19 August 2019

Pearl High School Multipurpose Building

## ADDENDUM NO. 01

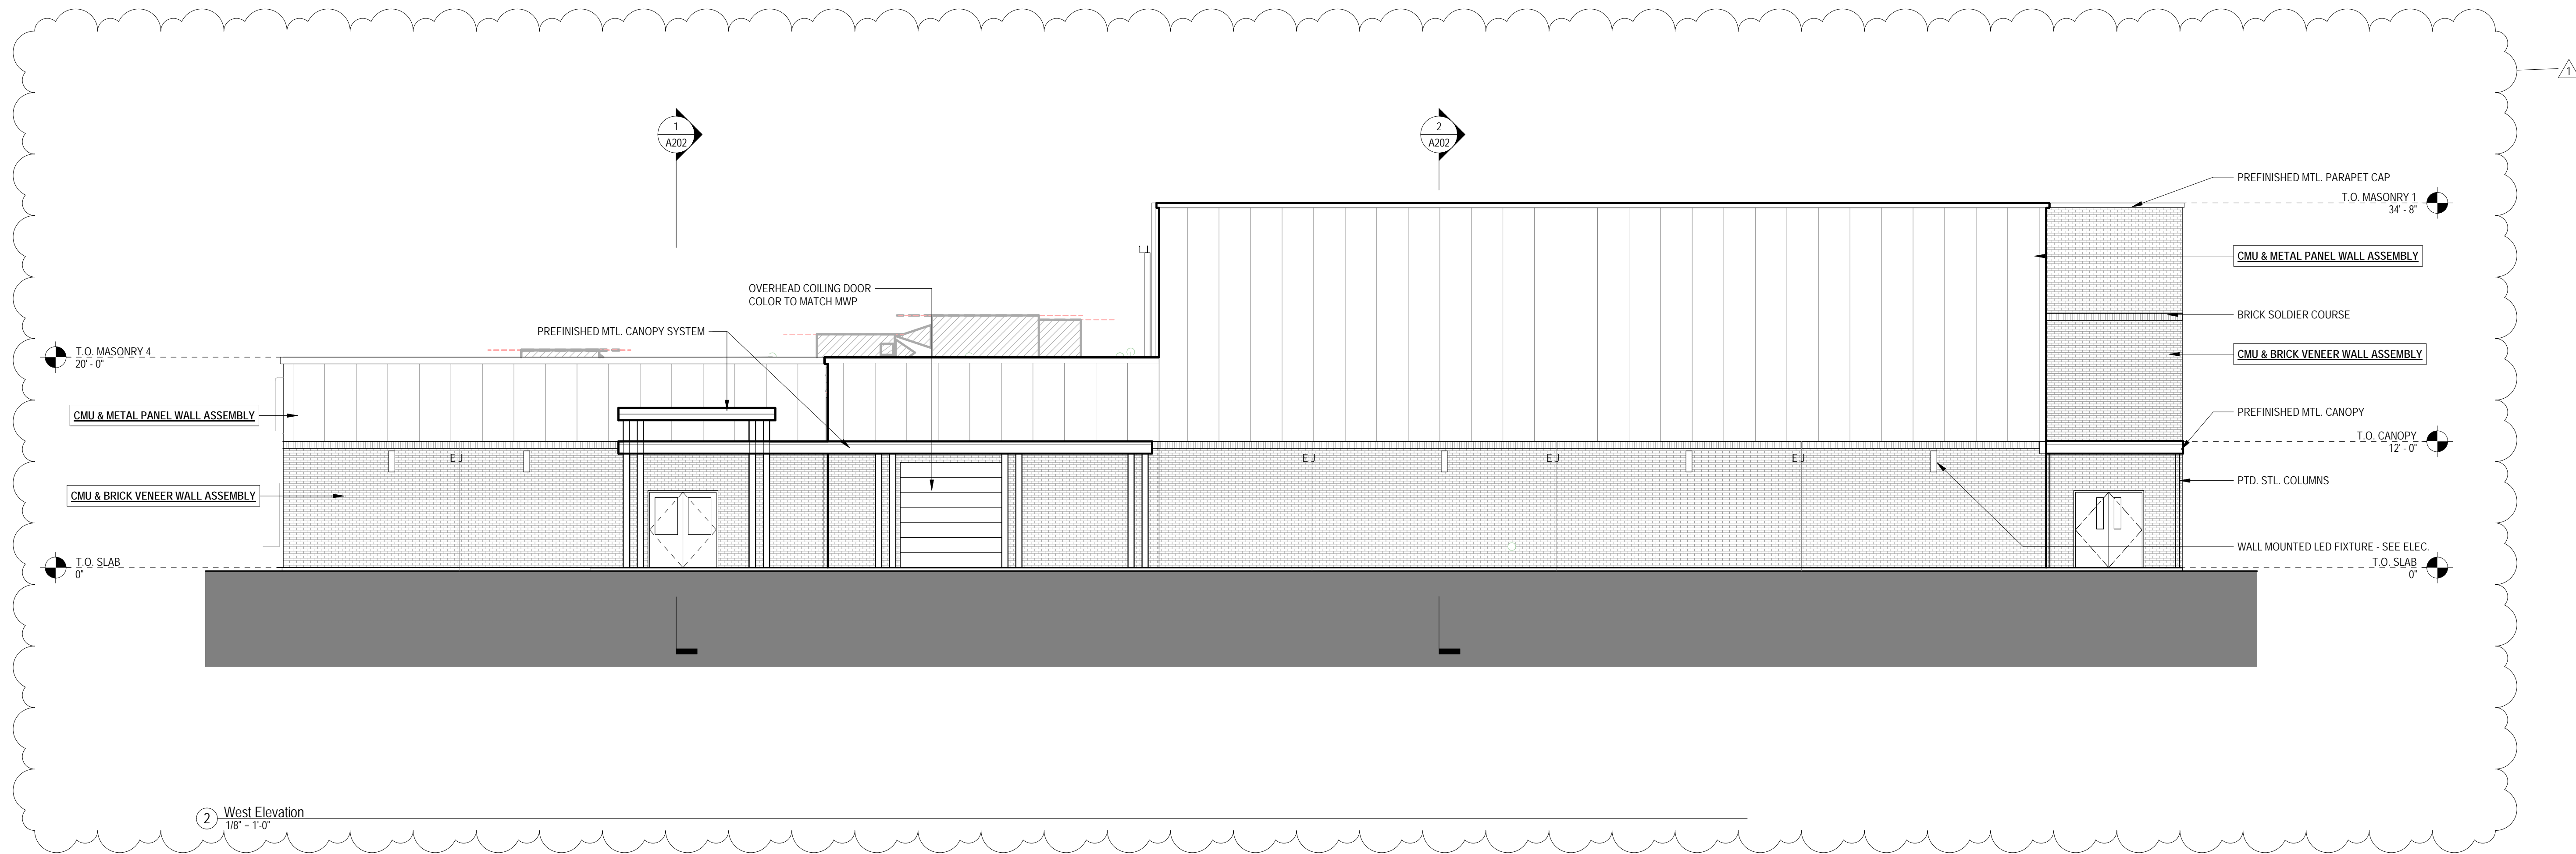
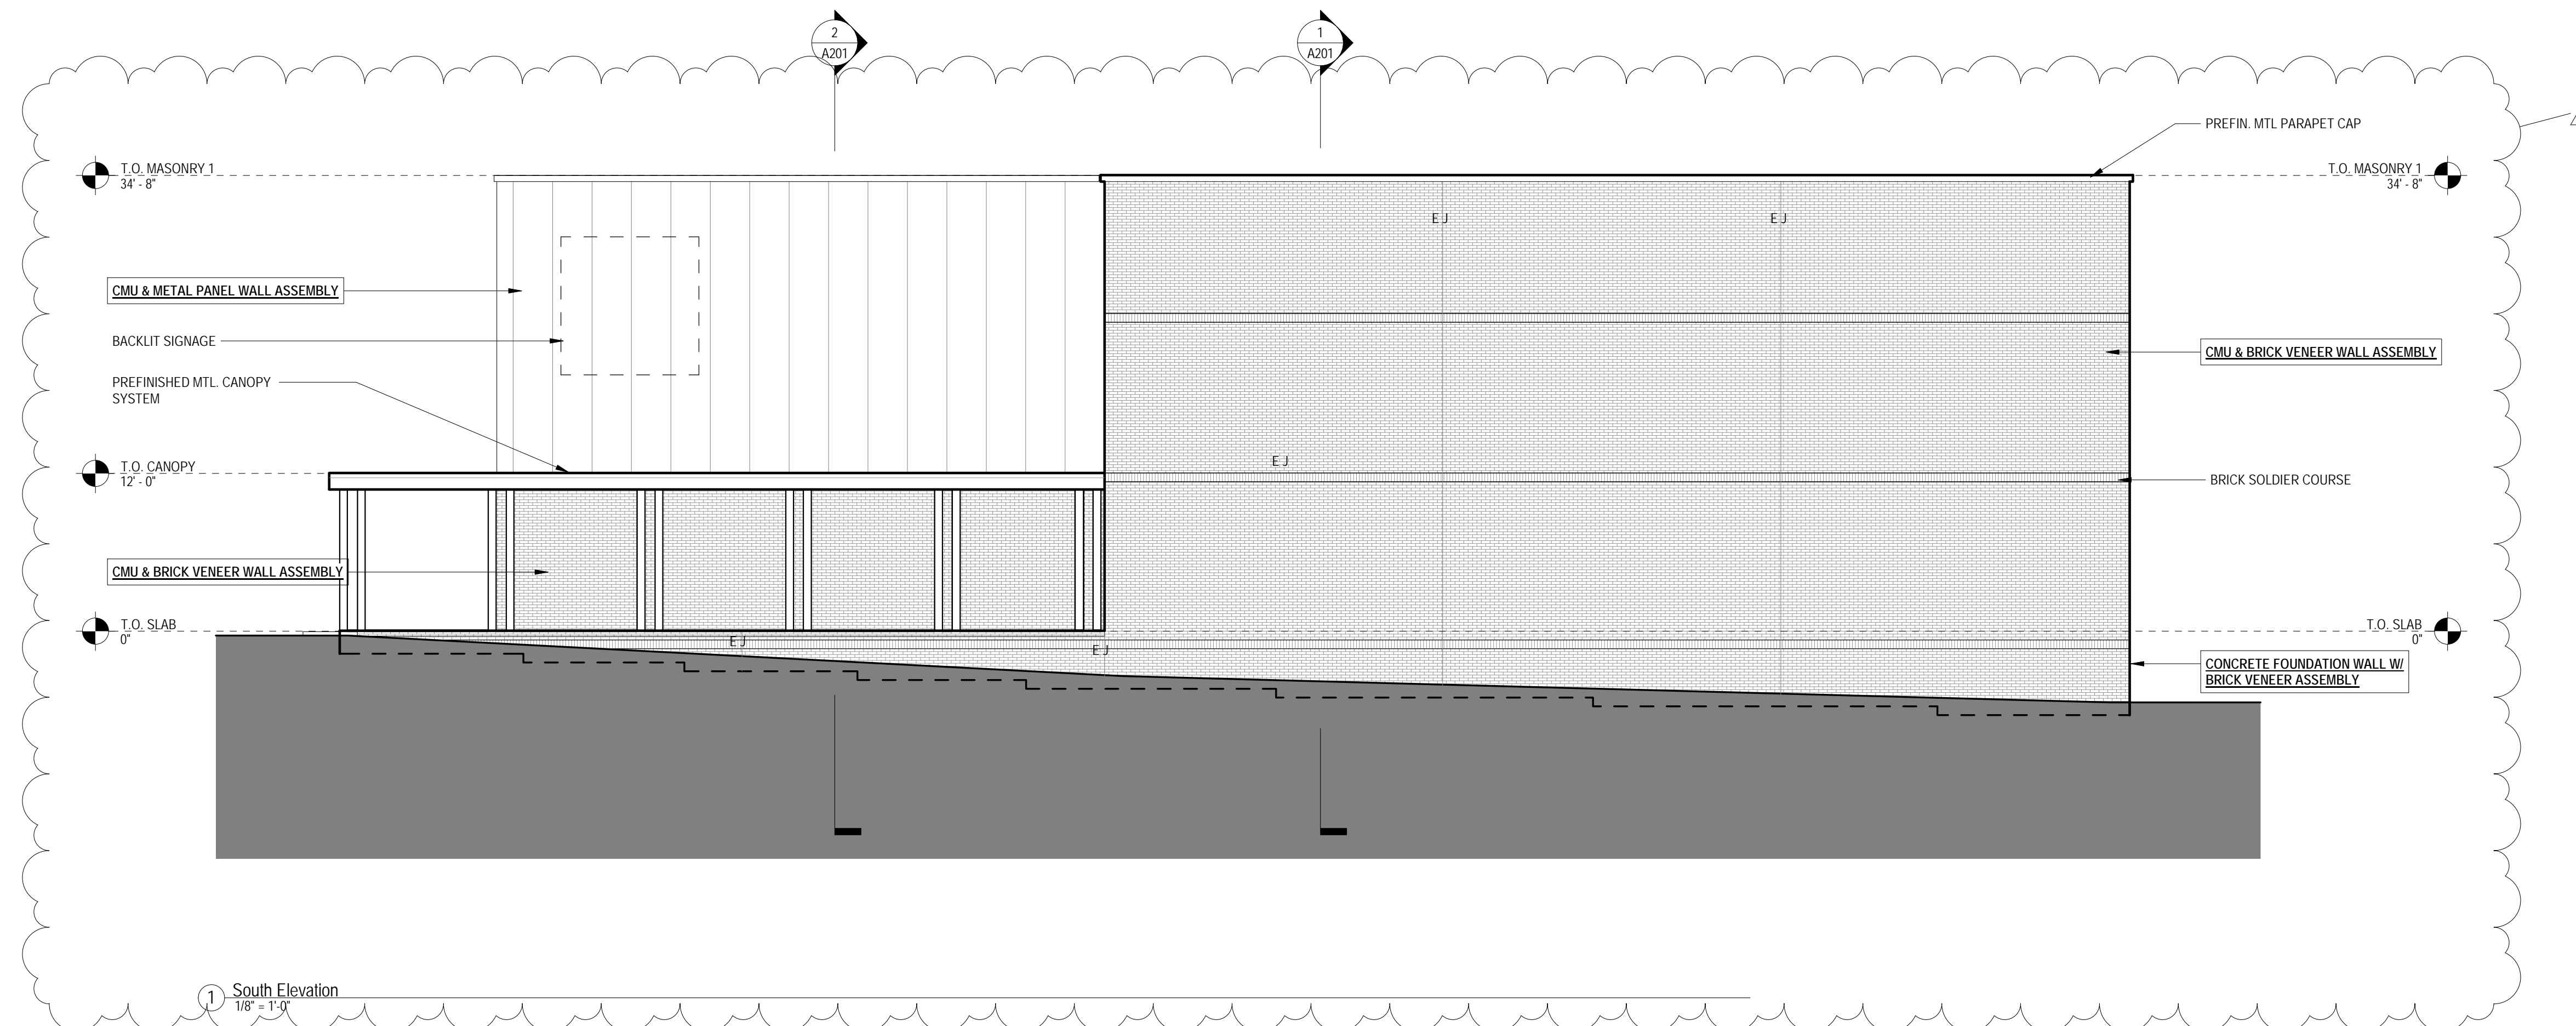
- ITEM NO. 44**      **SHEET A301 BUILDING ELEVATIONS**  
*REPLACE* sheet with attached revised sheet A301.  
*REVISES* Graphics of metal wall panel and Roof assembly legend

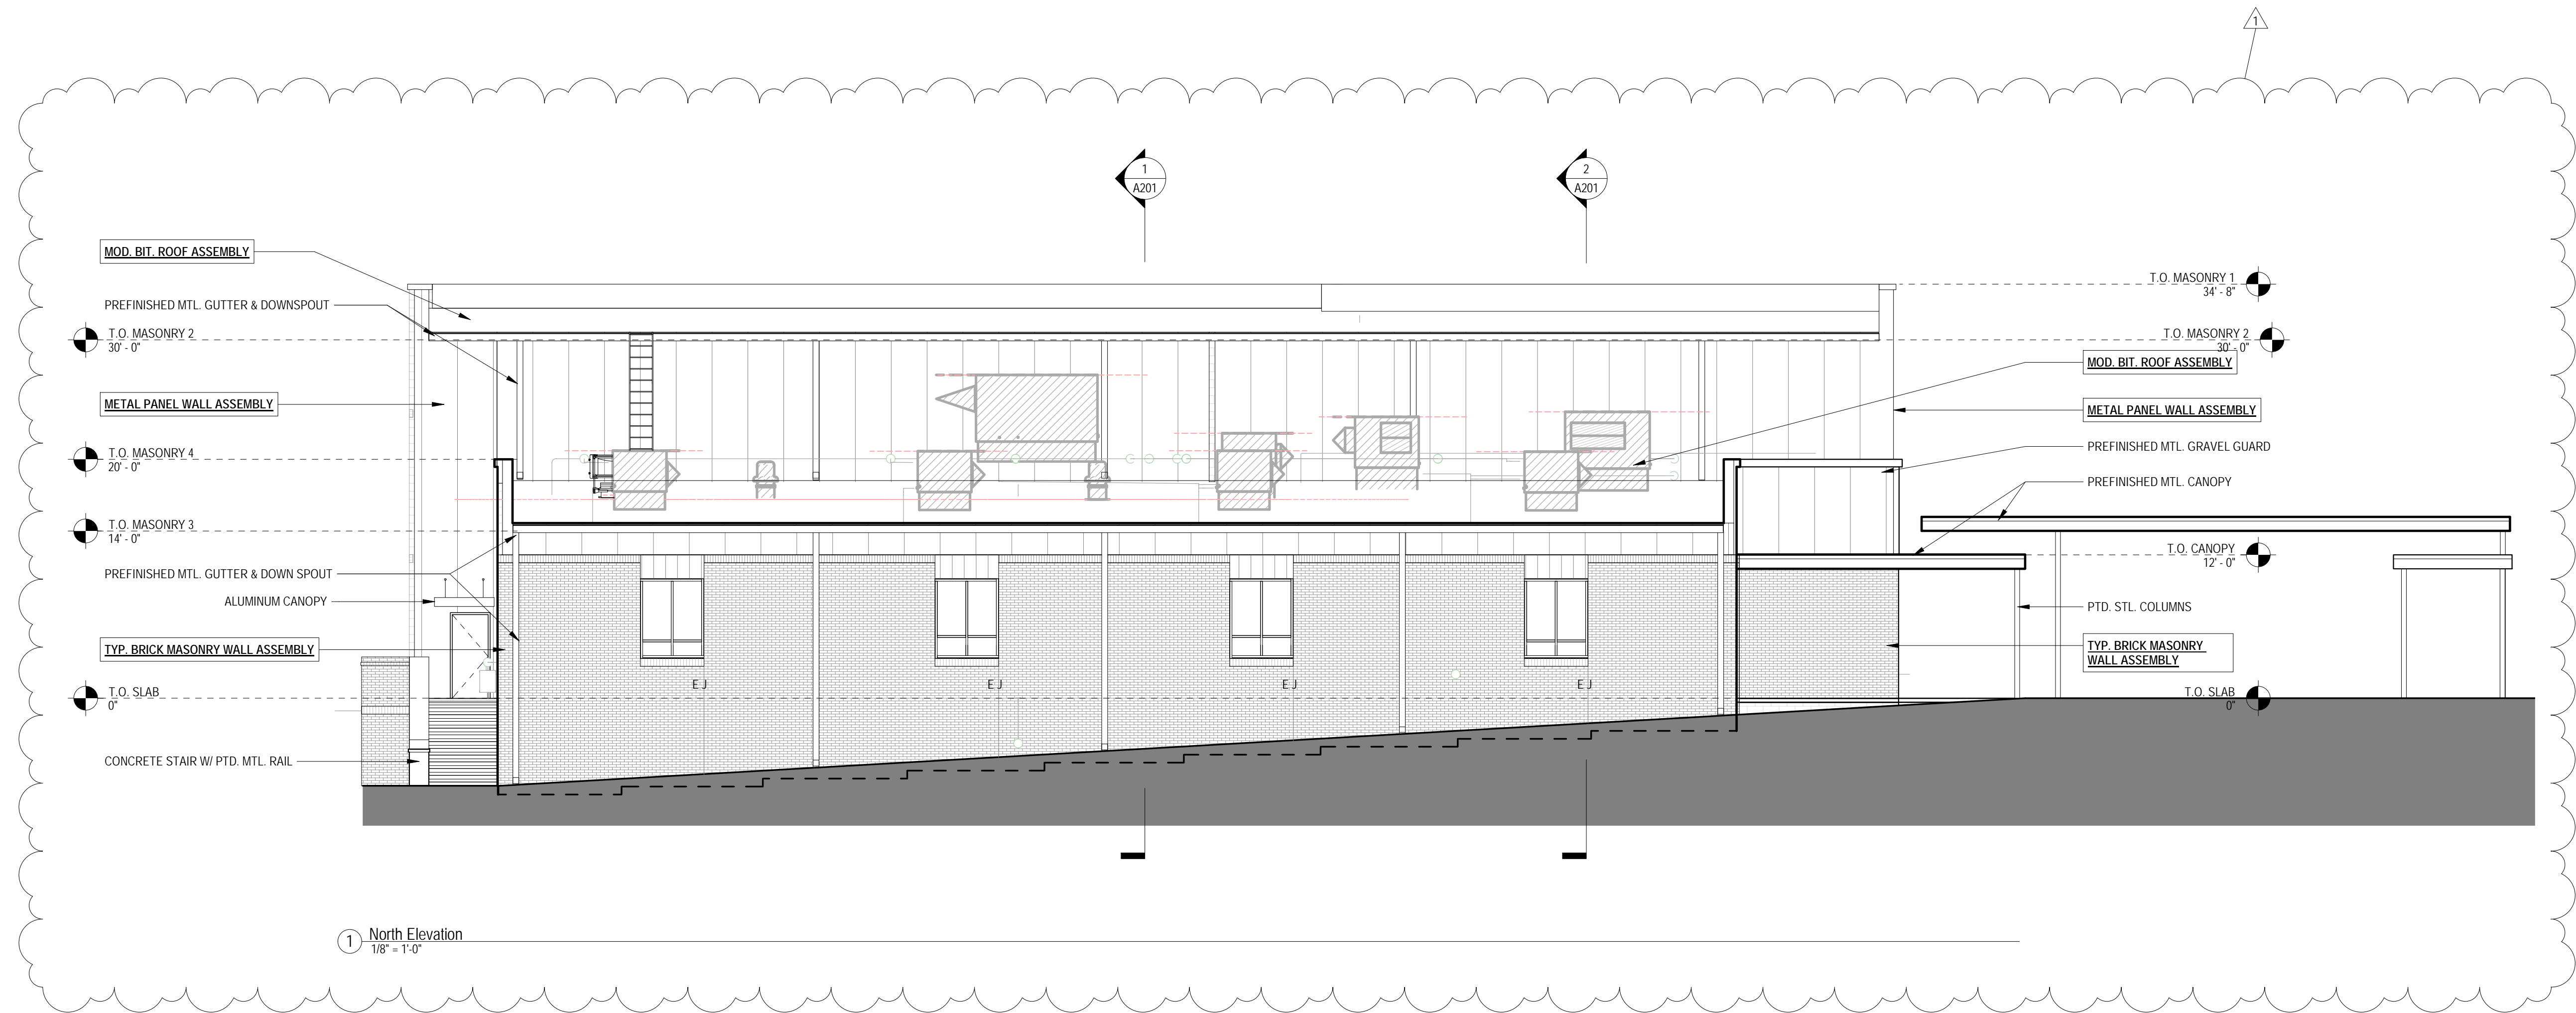
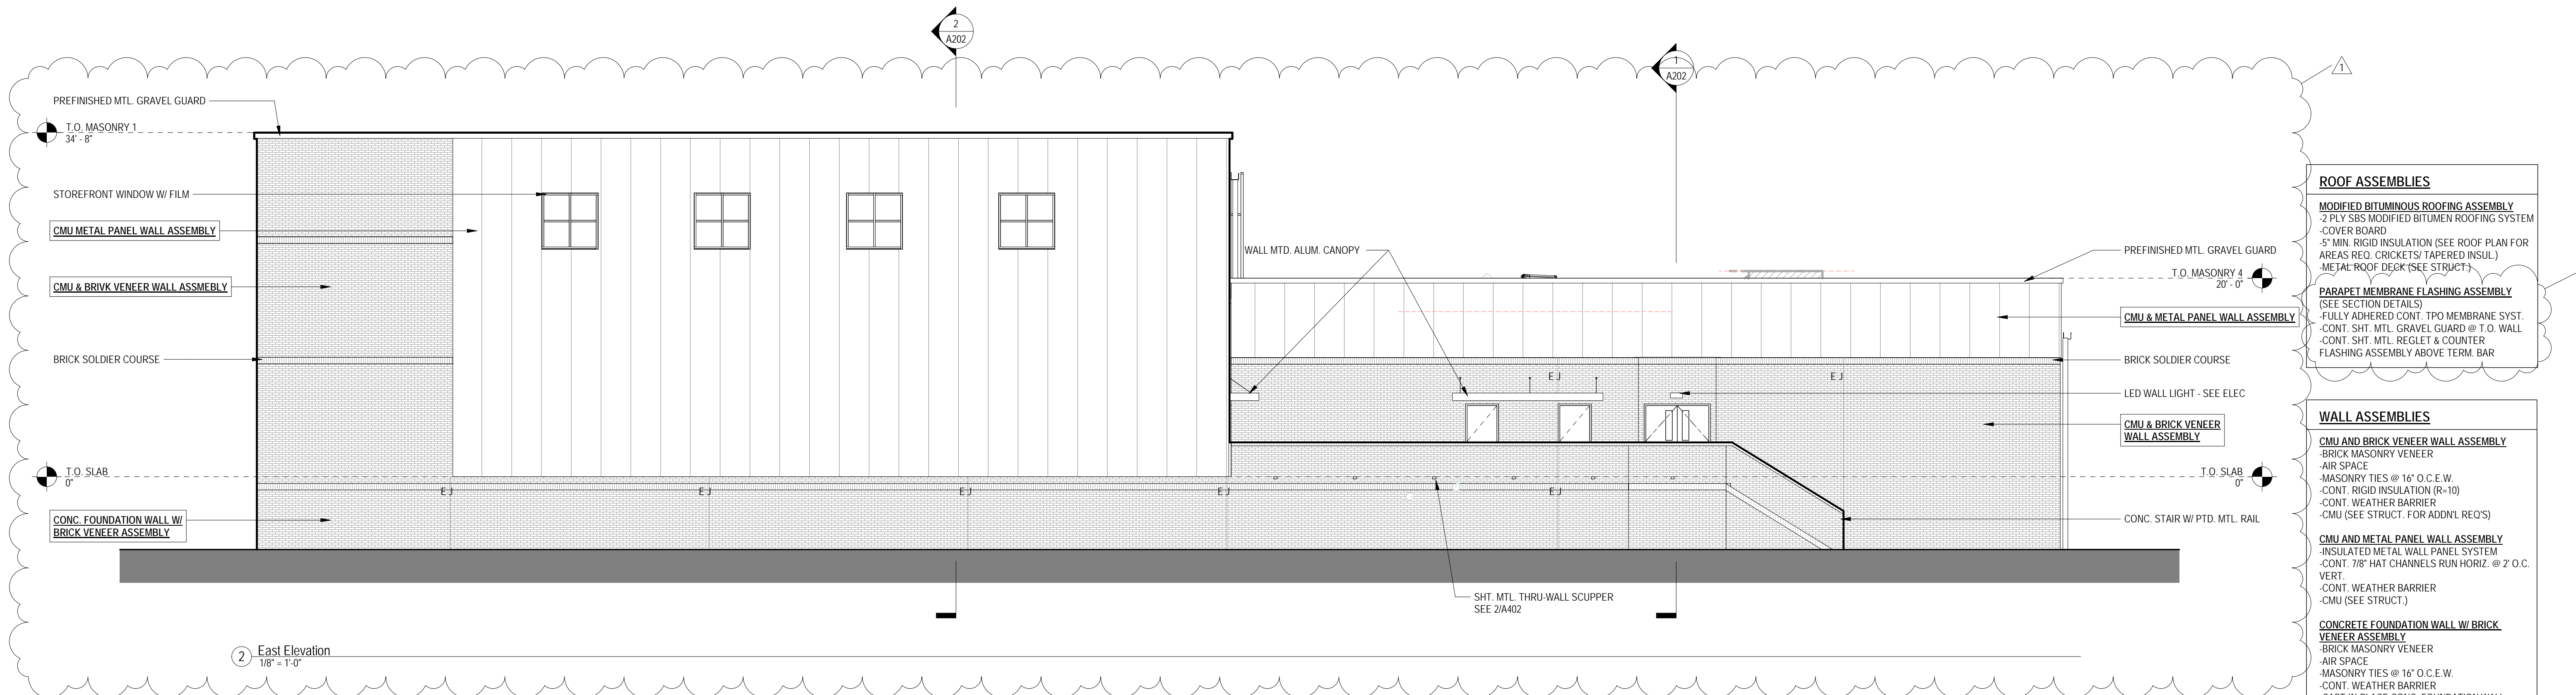
- ITEM NO. 45**      **SHEET A302 BUILDING ELEVATIONS**  
*REPLACE* sheet with attached revised sheet A302.  
*REVISES* Graphics of metal wall panel and Roof assembly legend
